NORTH TAHOE BEACH

CALIFORNIA TAHOE CONSERVANCY

ADA SELF-EVALUATION AND TRANSITION PLAN

NT-9

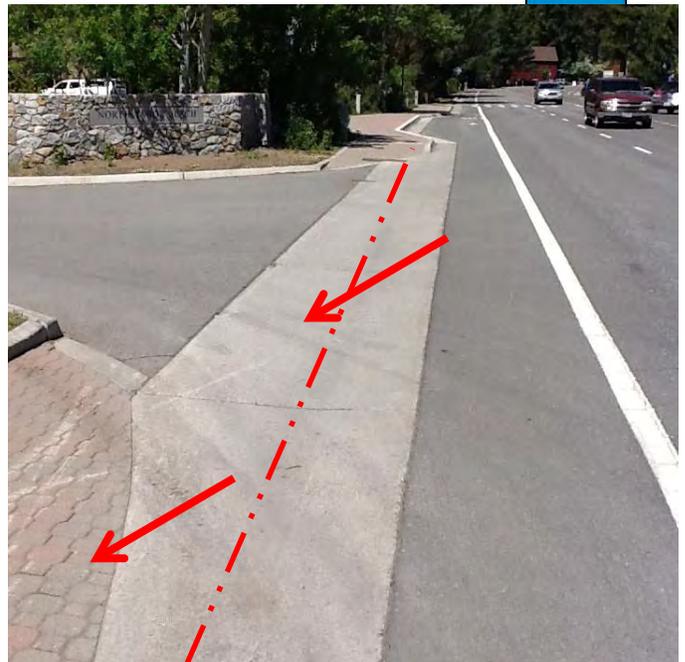
Ramp/flush transition lacks truncated domes. The V-gutter cross slope exceeds 2%.

Walkway lacks truncated domes at flush transition to vehicular way. Excessive slopes exist at rolled portion of curb.

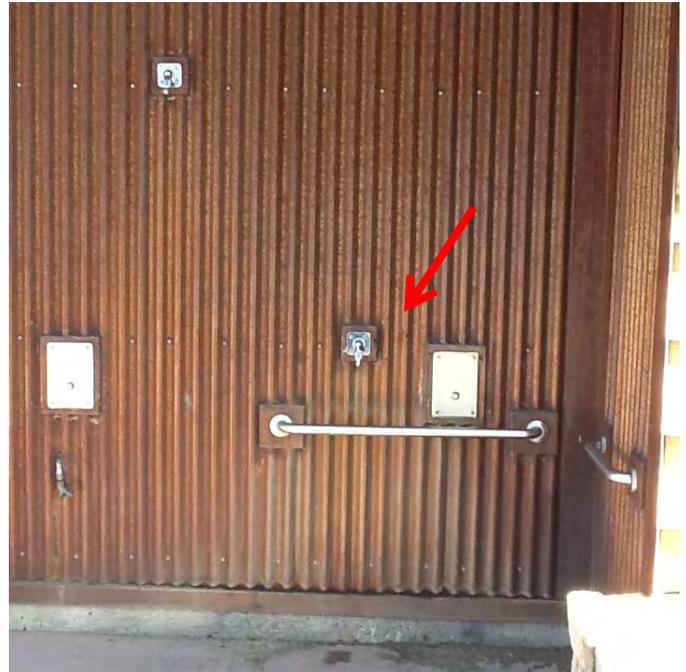
Electrical outlet exceeds maximum height above finish floor (41 1/2" instead of 40" allowable maximum).

Grab bar is incorrectly offset. A 12" and 24" offset is required. The toilet seat exceeds maximum height above finish floor (19 1/2" instead of 19" maximum).

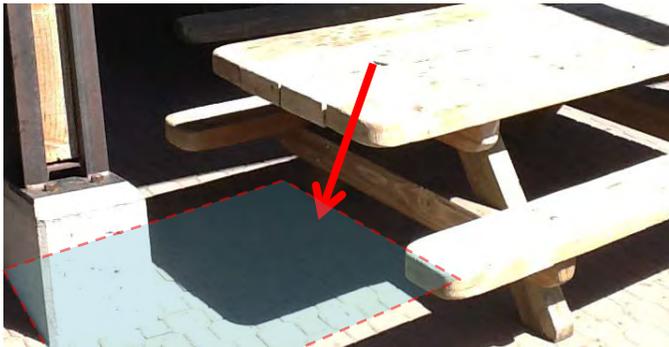
Inadequate clear space is provided on the approach to the accessible table. An accessible picnic table must provide a 30"x48" wheelchair space and provide for the allowed knee space within those limits.

The current layout does not provide the required 36" clear space between and around the tables.
